NRC DOCKET 50-366
OPERATING LICENSE NPF-5
EDWIN I. HATCH NUCLEAR PLANT UNIT 2
THERMAL POWER MONITOR

NRC DOCKET 50-366
OPERATING LICENSE NPF-5
EDWIN I. HATCH NUCLEAR PLANT UNIT 2
PROPOSED DETERMINATION OF AMENDMENT CLASS

NRC DOCKET 50-366
OPERATING LICENSE NPF-5
EDWIN I. HATCH NUCLEAR PLANT UNIT 2
PROPOSED CHANGES TO TECHNICAL SPECIFICATIONS

NEW APRM SCRAM TRIP LOGIC FOR THE EDWIN I. HATCH NUCLEAR PLANT UNIT 2

FIGURE 1

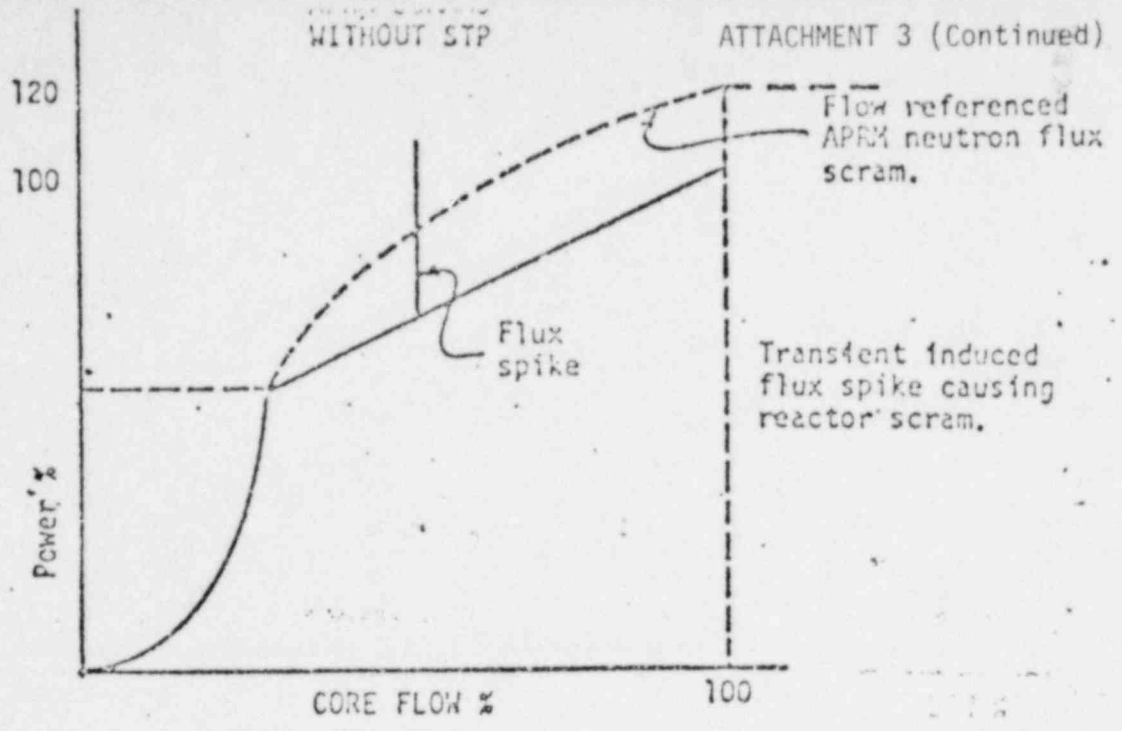
Although the present APRM flow reference scram system accurately predicts the thermal power level for steady-state operation, it overpredicts the fuel heat power level during power increase events. During such events, the neutron flux leads the reactor thermal power because of the fuel time constant. Therefore, neutron flux trip levels are reached before the reactor thermal power has significantly increased. While this anticipatory response in the APRM scram provides additional protection to the core during abnormal operational transients or accidents, it results in many unnecessary scrams for small neutron flux disturbances along the flow control line (Figure 1).

FIGURE 2

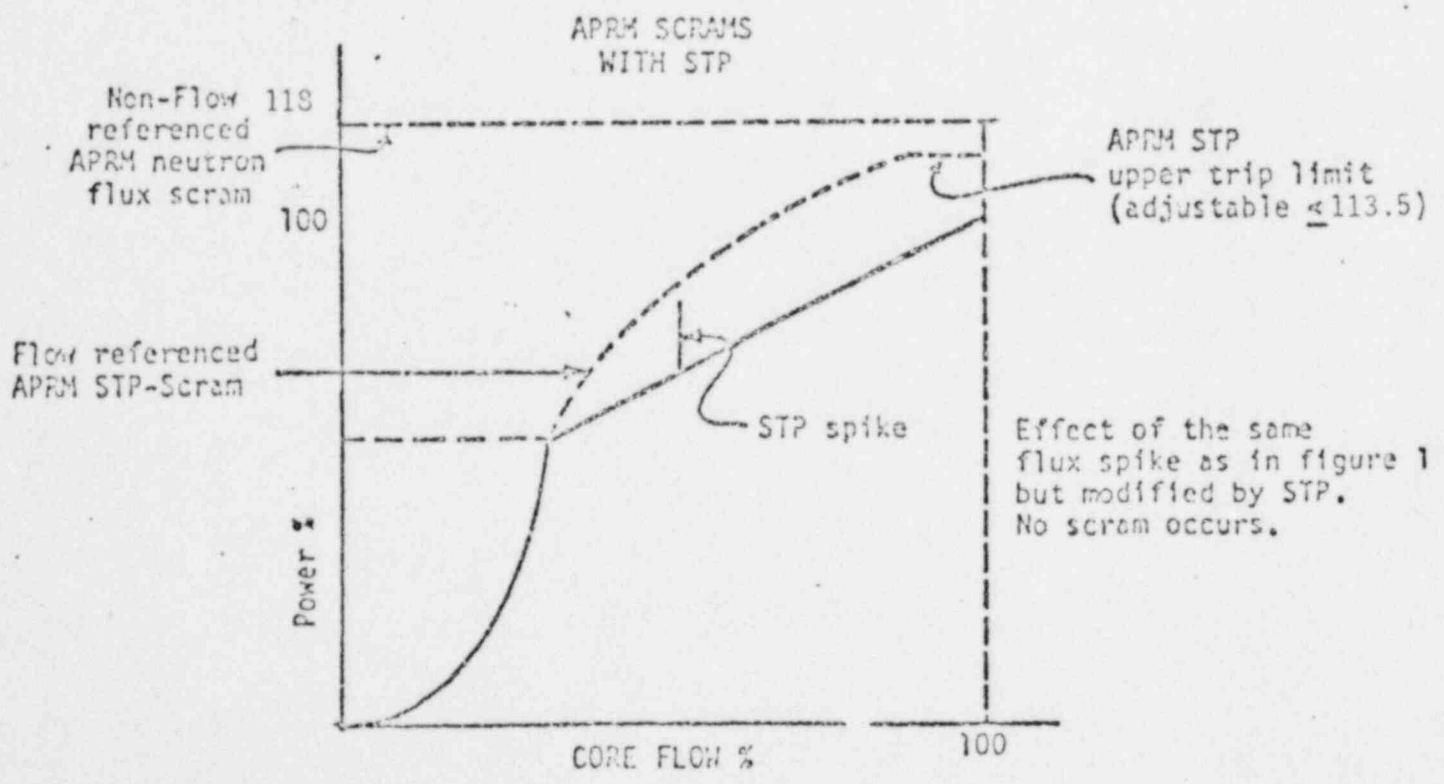
Figure 2 shows the response of the new APRM scram trip logic to the same flux spike as shown in Figure 1. In this case, a scram does not occur, since the transient peak of the simulated thermal power is below the flow referenced scram setpoint.
